## Technical Change of 3C 302-200 P01/P03

blacktech Number	OEM Part Number	Cross References	Application
<b>3C 302-200 P01</b>	Gigant 881204	Conti FT 412-32 1/2 M10	Trailer
<b>3C 302-200 P03</b>	Fruehauf M 00 2297	Dunlop SP 2666 NB	Trailer

**3C 302-200 P01/P03**

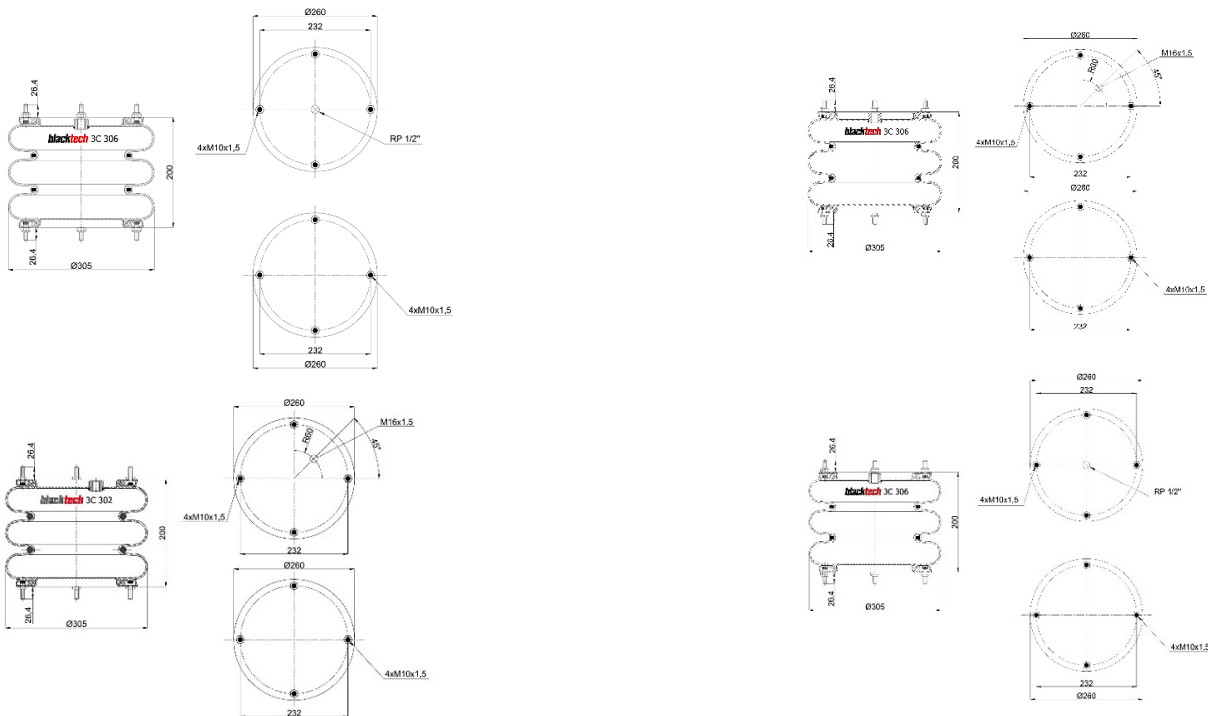
In order to improve the efficiency of former Blacktech Versions **3C 302-200 P01** and **3C 302-200 P03** we will switch to the revised versions **3C 306-200 P01** and **3C 306-200 P03**. In this case we will use instead of the metal ring, a steel ring consisting of a combination of many wires, which will be implemented during the vulcanization process. This will have a positive effect on the durability of our products.

**3C 306-200 P01/P03**
